Our Ref: 1182 Westland Horticulture

Your Ref: P0914-01

**Re: Article 11 Request for Further Information in support of Application for
IPPC Licence (21.September. 2010)**

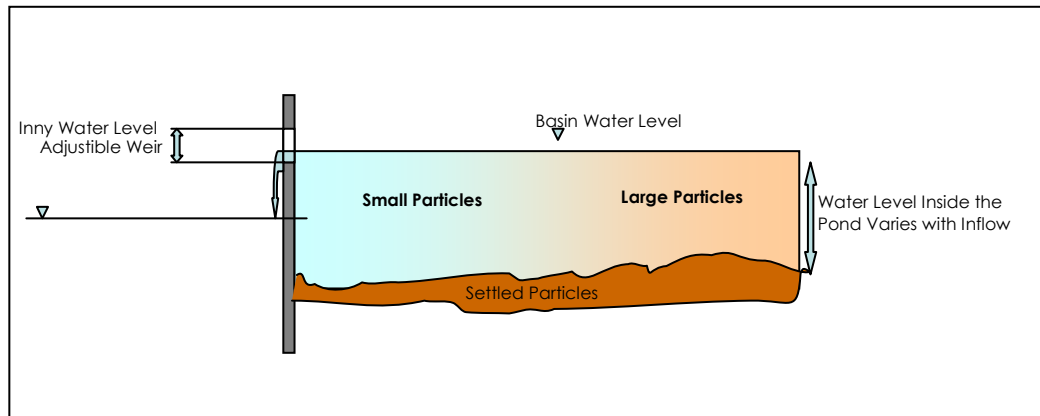
2. Submit data for the maximum water levels in the River Inny, including the dimensions of the weirs, and justify the assertion that the adjustable weirs at the settlement ponds can address rising water levels.

3. Determine the potential for settlement pond flow to pass under the adjustable weirs and thereby avoid settlement. Justify you answer by way of engineering details and drawings as appropriate.

The outlets of all of the weirs installed at the site have the same dimensions, they are 150mm high and 320mm wide. A diagram of the weirs is appended as Appendix F.2.1. As illustrated in the drawing, the discharge point can be adjusted to allow for the 'stage' in the Inny, the weir can also be adjusted as the water level of the basin rises and falls.

The discharge from the sedimentation basins is designed to flow over the settlement basin weir once the water reaches a certain level inside the basin, as illustrated in the sketch below.

If the flow into the pond is greater than that exiting over the weir, an adjustment can be made to increase the storage volume. The adjustment to the weir is made by moving the 150mm timber blocks up or down. Losses of silt through the gaps in the timber blocks are considered to be negligible as water at the weir interface will be at its lowest suspended solids concentration, as the larger silt particles settle out first as illustrated above. In addition, the total surface area between the timber blocks is circa 0.00075m², this space will not permit any water of significance to be discharged.
